Item No. 11.1.3
Halifax Regional Council
August 4, 2015

SUBJECT: Cessation of Train Whistle – King Street Railway Crossing, Dartmouth

Re : Grade Crossing Safety Assessment :
King St,
Dartmouth Sub - Mile 12.99

M.12.99- King St. Sketch

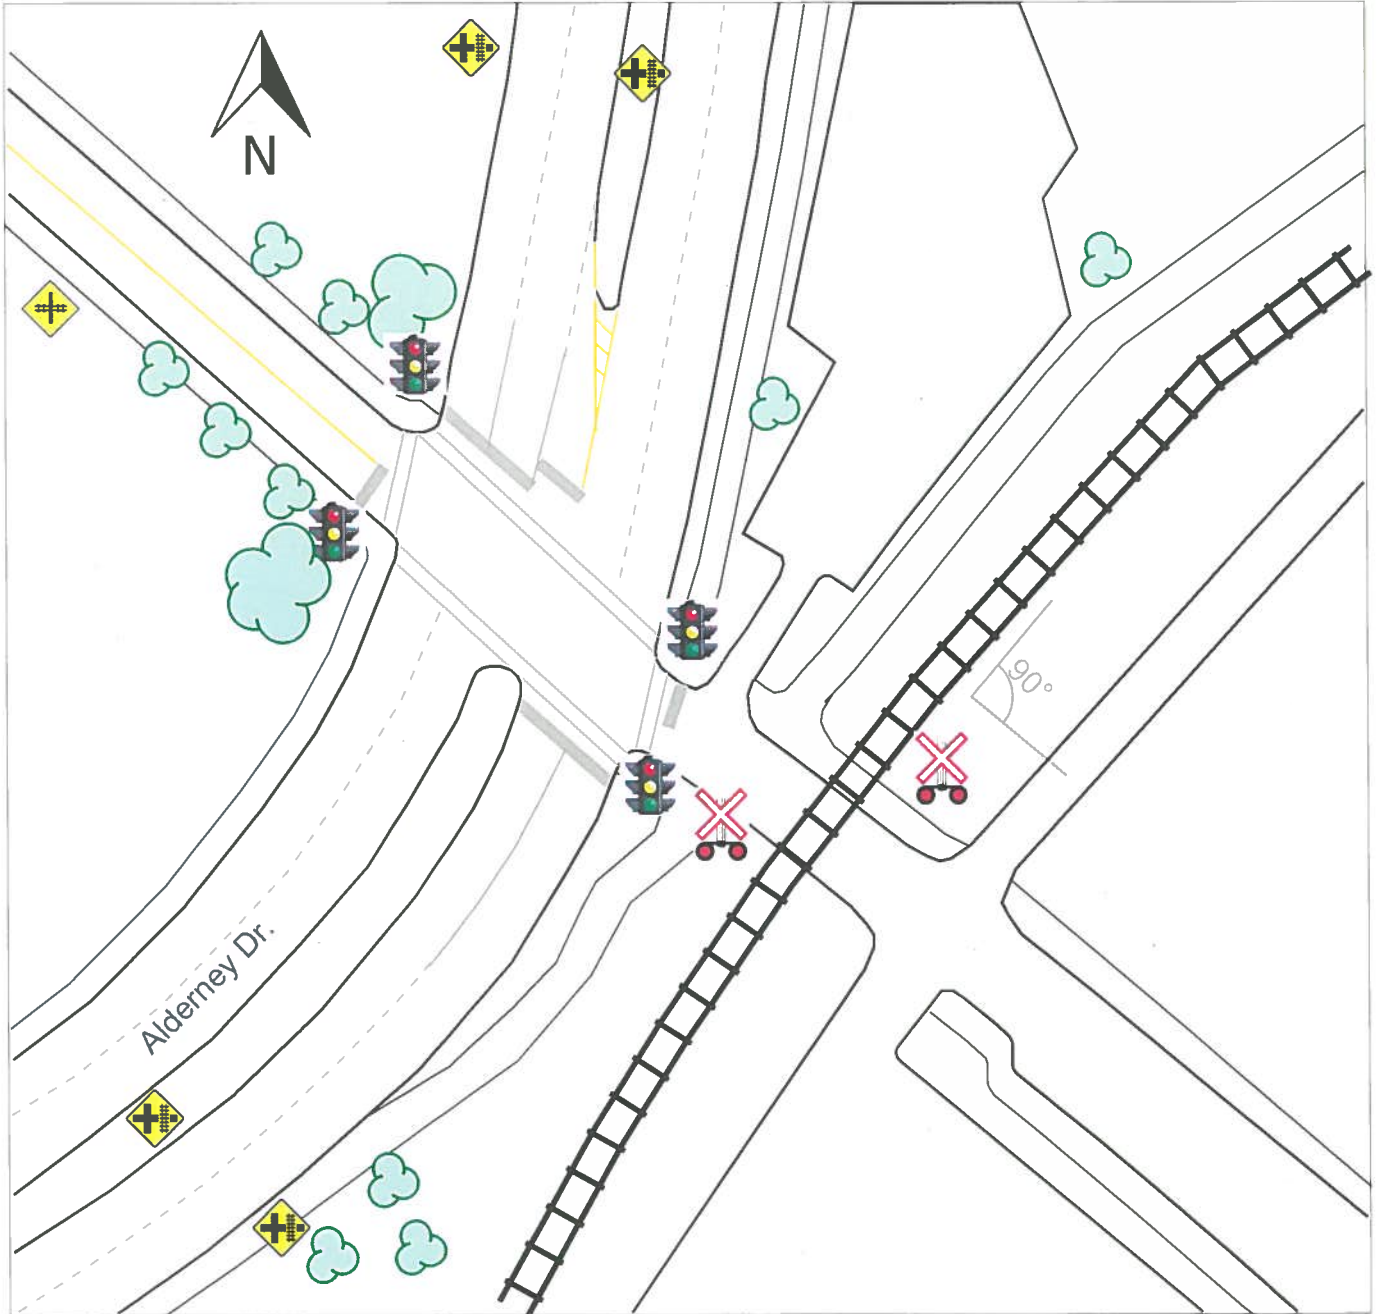
Observations	Suggested Actions	To	Client Response
1 NW quadrant -Crossing sign hidden by lights (see photo 9).	Adjust position of crossing sign and lights	Railway	Comments
2 NW Quadrant - Evidence of routine unauthorized access (trespassing) on the rail line (see photo 11)	Sidewalk is needed as well as fencing to prevent trespassing.	Railway/Road authority	
3 NW Quadrant - Advanced warning sign is not at the appropriate distance from the North side.	Reposition WA-18 sign on King St. 110m from crossing.	Road authority	
4 NW Quadrant – Potential Traffic queuing onto intersecting roadway from crossing	No right turn on red signal needed for right turn from Alderney Drive to King Street towards crossing.	Road authority	
5 NW/NE Quadrant - crossing sign obscured by trees (see photo 8)	Trim or remove trees to improve visibility of crossing signs	Road authority	
6 NE Quadrant – Sidewalk not protected by gates and lights	Pedestrian gates and lights are needed for sidewalk on the NE side of crossing.	Railway

7 SE Quadrant - Advanced warning sign is not at the appropriate distance from the crossing.	Add WA-18 signs on King St. 110m from crossing.	Road authority	
8 SE Quadrant - Pavement markings are missing.	All required pavement markings should be applied: “X” marking, “No Passing” lines, and “Stop” bars.	Road authority	
9 SE Quadrant -- Traffic queuing onto crossing from intersection	Do not stop on track sign needed for South approach.	Road authority

10	SW Quadrant – partial sidewalk/pathway not protected by gates and lights.	Pedestrian gates and lights are needed. Sidewalk should be completed on the SW side of crossing.	Road authority		
11	Crossing surface – Elevation of top rail is 40mm below crossing surface.	Crossing surface should be adjusted to be less than 25mm above the top of rail.	Railway/Road authority		
12	Gate descent time was measured at 7 seconds and gate arm delay was measured at 6 seconds	Gate descent time should be adjusted to be within 10 to 15 seconds and gate arm delay should be adjusted to 7 seconds.	Railway		
13	Parking lots on both sides of the road in the south approach to the crossing do not have light unit coverage (see photos 12 and 13)	Additional light units are required for drivers as they begin to turn onto the approach road from the two parking lots.	Railway/Road authority

Annex B – Board Plan

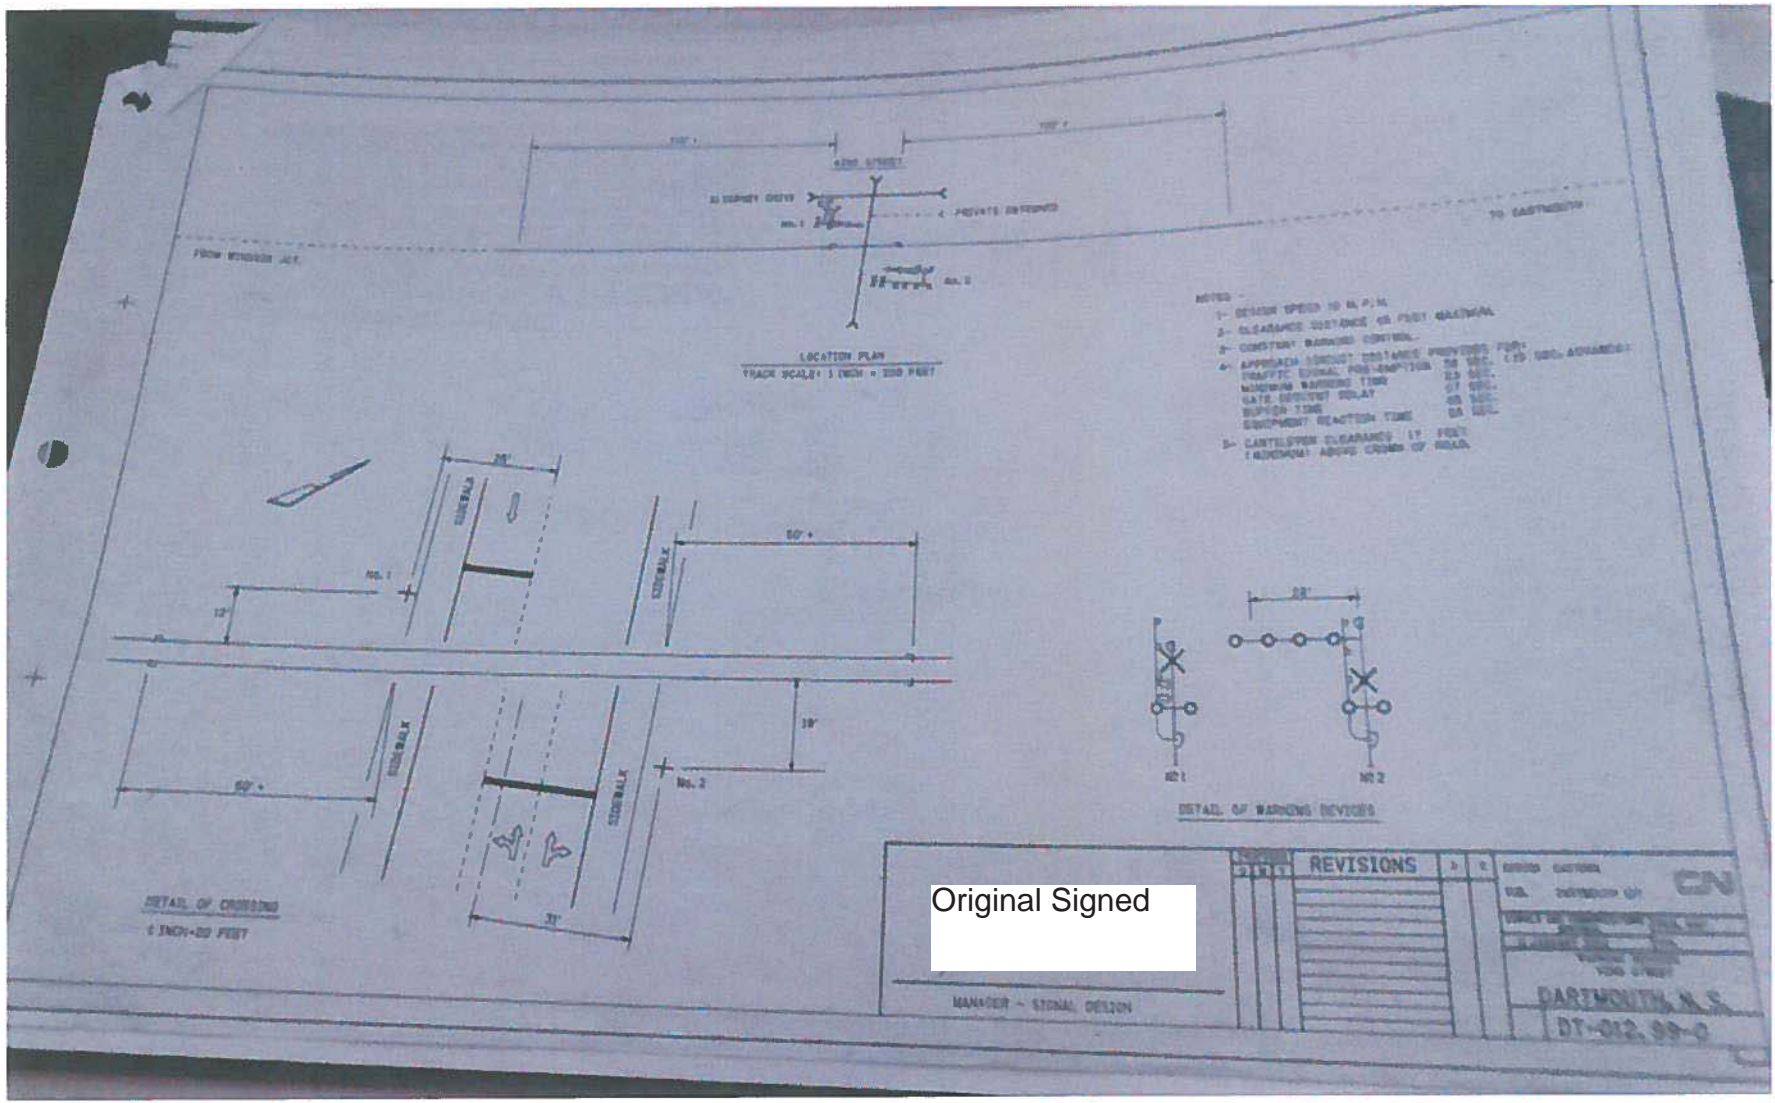
Requirement (received Feb 28 ¹⁵ from Hatch Mott and Macdonald).	Suggested Action	Responsibility	Status/Next Steps
1. NW quadrant – Crossing Sign hidden by lights.	Adjust position of crossing sign and lights	CN Rail	CN to adjust / relocate sign.

2. NW Quadrant – Evidence of routine unauthorized access (trespassing) on the rail line	Sidewalk is needed as well as fencing to prevent trespassing	CN Rail / Kings Wharf	Dexter Construction to complete as part of original contract.

3. NW Quadrant- Advanced warning sign is not at the appropriate distance from the North Side.	Reposition WA-18 sign on King St. 110m from crossing	HRM	Signage location was reviewed and determined that current placement is appropriate. CN agreed.

4. NW Quadrant – Potential Traffic queuing onto intersecting roadway from crossing.	No right turn on red sign needed for right turn from Alderney Drive to King Street towards crossing.	HRM	HRM is currently in discussions with Transport Canada to determine appropriate operation of traffic signal / grade crossing warning system interconnect as per the Grade Crossing Standards. This item is still outstanding, but is in progress.

5. NW/NE Quadrant – crossing sign obscured by trees.	Trim or remove trees to improve visibility of crossing signs.	HRM	HRM Urban Forestry was tasked with evaluating the situation and trim trees as appropriate.

6. NE Quadrant – Sidewalk not protected by gates and lights.	Pedestrian gates and lights are needed for sidewalk on the NE side of crossing.	CN Rail	CN Rail has determined this to be unnecessary.

7. SE Quadrant – Advanced warning sign is not at the appropriate distance from the crossing.	Add WA-18 signs on King's Wharf Place 110m from the crossing.	HRM	An appropriate location has been identified for this roadway approach and signage will be installed. CN in agreement.

8. SE Quadrant – Pavement markings are missing.	All required pavement markings should be applied 'X' marking. "No Passing" lines and stop bars.	HRM	HRM to install double stop bars at the grade crossing. "X" markings are not required. CN is in agreement with this approach.

9. SE Quadrant – Traffic queuing onto crossing from intersection.	Do not stop on track sign needed for South approach.	HRM	HRM to install "Do not stop on track" sign, but cross-hatching will not be required.

10. SW Quadrant – partial sidewalk/pathway not protected by gates and lights.	Pedestrian gates and lights are needed. Sidewalk should be completed on the side of crossing.	HRM	CN Rail has determined this to be unnecessary.

11. Crossing surface – Elevation of top rail is 40mm below crossing surface	Crossing surface should be adjusted to be less than 25mm above the top of rail.	CN Rail / HRM	Crossing surface to be reviewed at next scheduled maintenance and rehab date. Not required to request whistle cessation.

12.	Gate descent time was measured at 7 seconds and gate arm delay was measured at 6 seconds.	Gate decent time should be adjusted to be within 10 to 15 seconds and gate arm delay should be adjusted to 7 seconds.	CN Rail	CN has indicated that the equipment at the location is working properly and is in compliance with requirements.

13.	Parking lots on both sides of the road in the south approach to the crossing do not have light unit coverage	Additional light unit are required for drivers as they begin to turn onto the approach road from the two parking lots.	CN Rail / Kings Wharf	CN has determined that additional lights are required. They have provided a cost to have the lights supplied / installed and are requesting payment before scheduling the work.

14.	Access to Parking Garage during train crossing may be blocked causing queuing on tracks. (added by CN Rail)	Requires "hatching: in front of access to parking garage to prevent cars from blocking entry.	HRM	HRM will install additional signage related to blocking of the driveway as well as additional "Do not stop on tracks" signage. Painted hatching will not required.
